RE: North Domingo Baca Park

LOMR Request Engineer's Stamp Date: No Date

Hydrology File: C19D043

Based upon the information provided in your submittal received 08/09/2024, the LOMR Request **is not** approved by the City of Albuquerque. The following comments need to be addressed for approval of the above referenced project:

> LOMR EXHIBIT 2

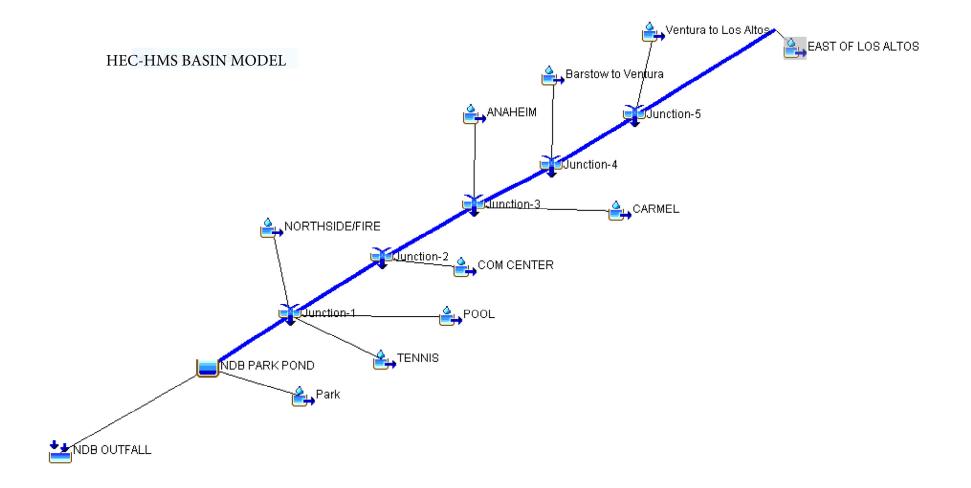
- 14. On Exhibit 2, please change Ndb Park Pond to Kinney Dam.
- 15. Under HEC-RAS, please indicate what version of HEC-RAS was used in the calculations.
- 16. In With the HEC-RAS model, please use a 6'x10' double barrel box culvert for the sections. The section shown appears to be a channel and not a box culvert. There will need to be a section of the upstream channel, the box culverts, and the channel which outfalls into Kinney Dam. Please update the model.
- 17. On the Revised FIRM (LOMR Exhibit 5), Please show the box culvert as the black dashed line that needs to stay.
